SUNDRY NOTICES AND REPORTS ON WELLS
Do not use this form for proposals to drill or to re-enter an abandoned well. Use form 3160-3 (APD) for such proposals.

8. Well Name and No.
SEMU 10

9. API Well No.
30-025-07849-00-C2

**Permanent Abandonment of Federal Wells
Conditions of Approval**

SEMU #10			
WELLBORE DIAGRAM			
30-025-07849			
FIELD: Blinebry-Tubb-Drinkard			
CO ST: Lea, NM		AREA: Hobbs East	
SECTION: 29	TOWNSHIP: 20S	RANGE: 38E	
LOCATION: 1980' FNL & 1980' FWL			
SPUD: 3/6/49		IC: 7/4/49	
LATEST RIG WORK:		1/8/08	
DIAGRAM REVISED:

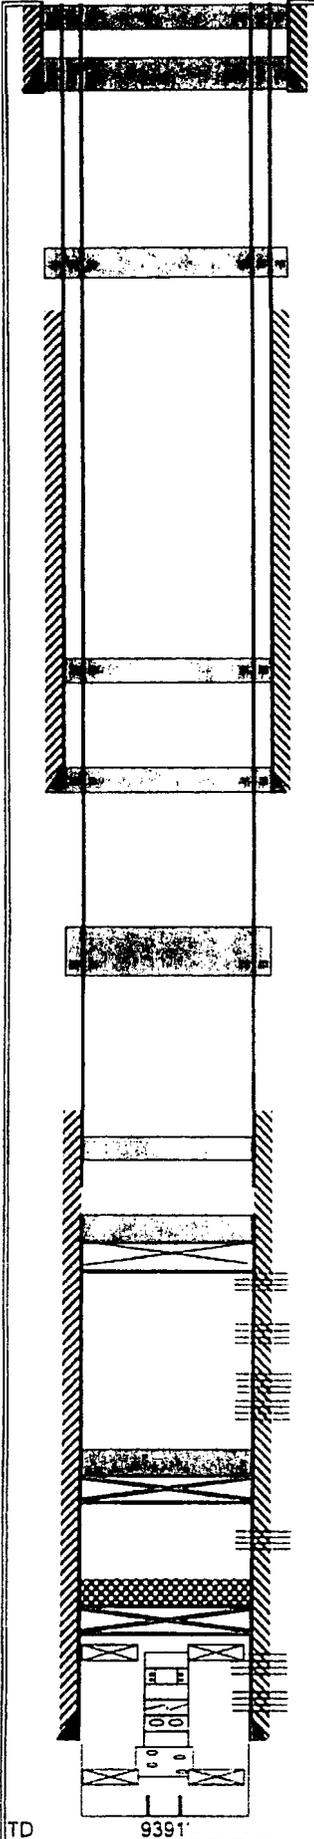
- 1) MIRU. ND WH, NU BOP. POOH w/ Prod Equipment
- 2) RIH Tbg - Tag BP @ 7600'. Spot 255x cmt on top to 7500' 35 5x To 7430, Add. Aug. Spot 35 5x.
- 3) Set CIBP @ 5910'. Circ hole w/ MLF. Pressure test csg From 6995 - 6825' or.
- 4) Spot 255x cmt @ 5910'-5840' 5750 (35 5x) Set CIBP @ 6945, Dump.
- 5) Spot 80sx cmt @ 5651'-5242'
- 6) Perf & Sqz 190sx cmt @ 4047'-3404'. WOC-Tag 4097 - 3454 35' WOC Tag.
- 7) Perf & Sqz 50sx cmt @ 2956'-2833'. WOC-Tag
- 8) Perf & Sqz 45sx cmt @ 2678'-2558'. WOC-Tag 2742 - 2612
- 9) Perf & Sqz 80sx cmt @ 1630'-1510'. WOC-Tag Deep Shots 7" & 9 5/8"
- 10) Perf & Sqz 80sx cmt @ 276'-176'. WOC-Tag
- 11) Perf & Circ 50sx cmt @ 60'-3'
- 12) POOH, top off well. RDMO. Cut off WH & anchors, install P&A marker

SEE ATTACHED FOR
CONDITIONS OF APPROVAL

SEMU #10				
WELLBORE DIAGRAM				
30-025-07849				
FIELD: Blinebry-Tubb-Drinkard				
CO ST: Lea, NM		AREA: Hobbs East		
SECTION: 29	TOWNSHIP: 20S	RANGE: 38E		
LOCATION: 1980' FNL & 1980' FWL				
SPUD: 3/6/49		IC: 7/4/49		
LATEST RIG WORK:		1/8/08		
DIAGRAM REVISED:

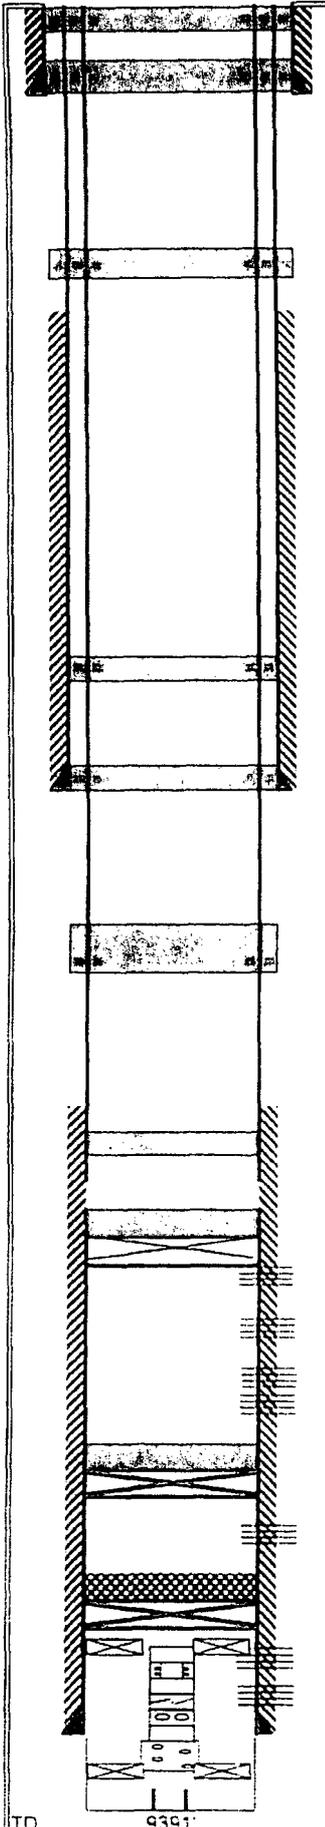
5. **Cement Requirement:** Sufficient cement shall be used to bring any required plug to the specified depth and length. Any given cement volumes on the proposed plugging procedure are merely estimates and are not final. Unless specific approval is received, no plug except the surface plug shall be less than 25 sacks of cement. Any plug that requires a tag will have a minimum WOC time of 4 hours.

In lieu of a cement plug across perforations in a cased hole (not for any other plugs), a bridge plug set within 50 feet to 100 feet above the perforations shall be capped with 25 sacks of cement. If a bailer is used to cap this plug, 35 feet of cement shall be sufficient. Before pumping or bailing cement on top of CIBP, tag will be required to verify depth. Based on depth, a tag of the cement may be deemed necessary.

Unless otherwise specified in the approved procedure, the cement plug shall consist of either Neat Class "C", for up to 7,500 feet of depth or Neat Class "H", for deeper than 7,500 feet plugs.
